### **REMARKS/ARGUMENTS**

Appl. No. 10/037,278  
Amdt. dated May 25, 2006  
Reply to Office Action of January 25, 2006

**FIG. 5A**

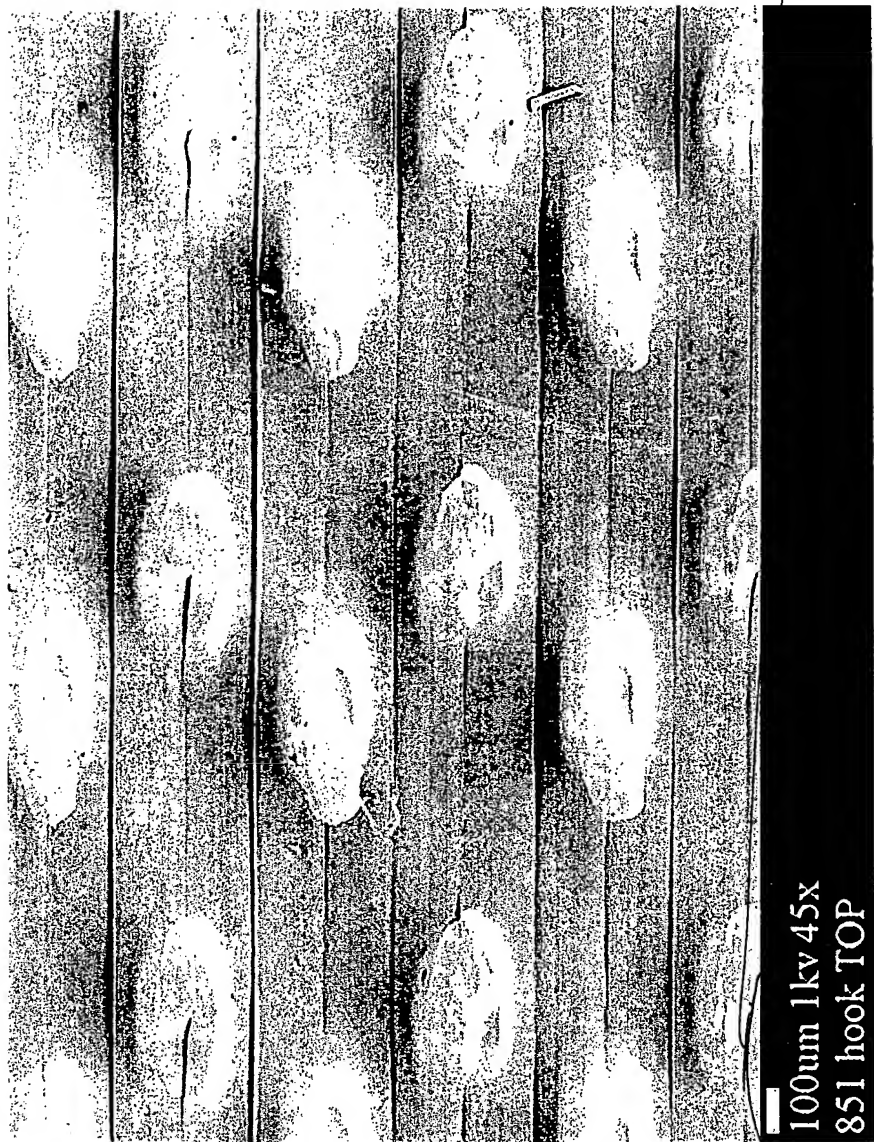
Next the Examiner objects to Figs. 5A, 5B, 6 and 7 on the basis that descriptive text should be avoided. Applicants respectfully point out that corrected photomicrographs were

*removed*

As can be seen, Figs. 5A, 5B, 6 and 7 as submitted herewith, and with the amendments of January 15, 2004 and July 28, 2004 clearly do not have any descriptive text. Therefore, Applicants respectfully request that the Examiner withdraw the objections to the drawings for the reasons set forth above.

**FIG. 5B**

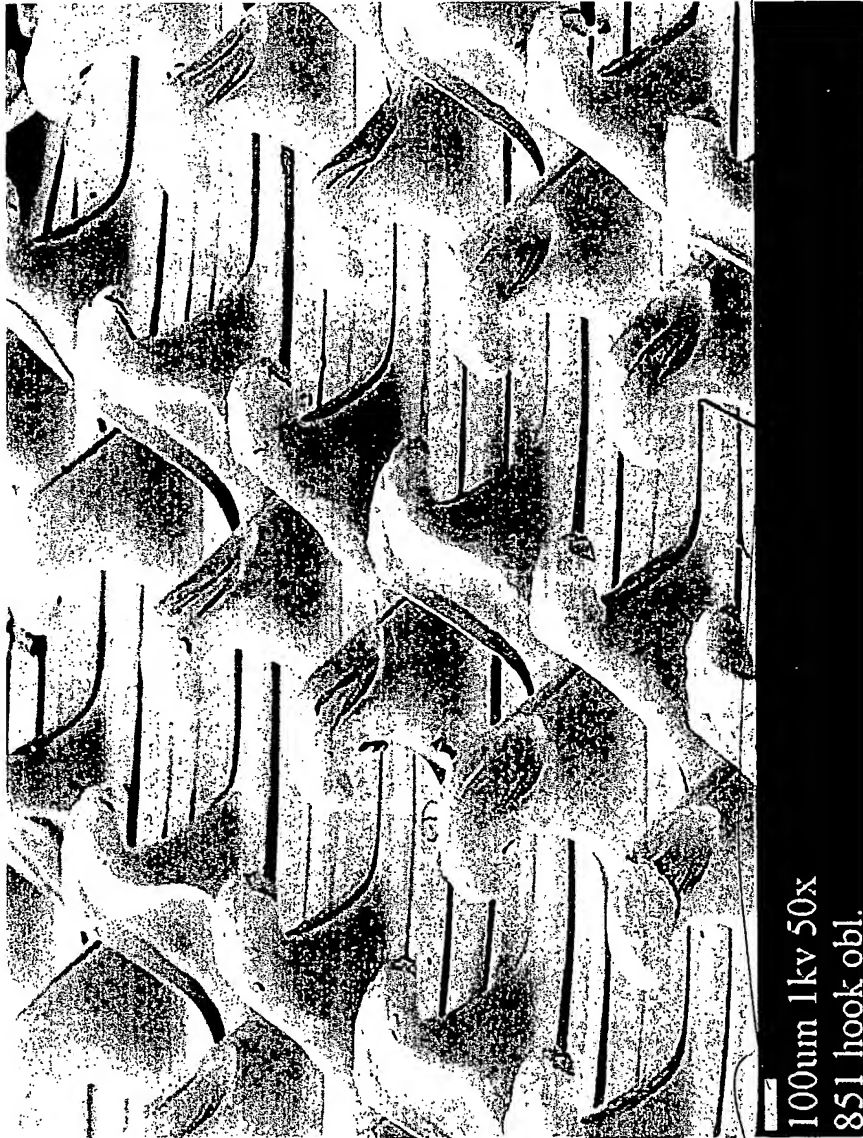
*Remove*

**FIG. 6**

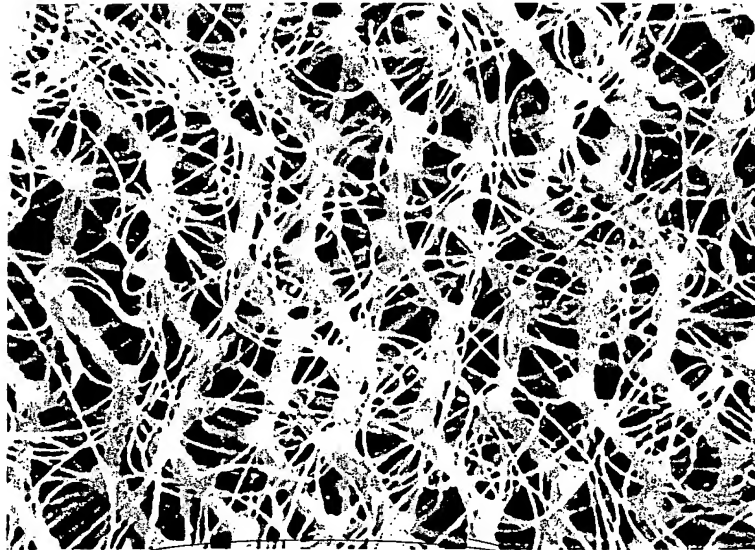
Guilford Woven Loop

*Remove*

**FIG. 7**

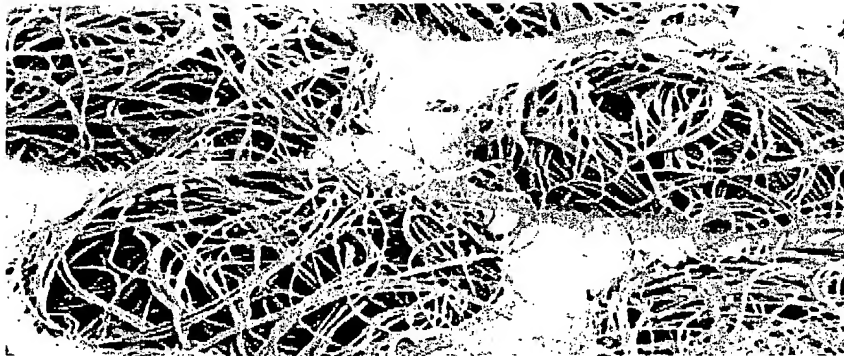
Nonwoven PUB Loop Dots

*Remove*
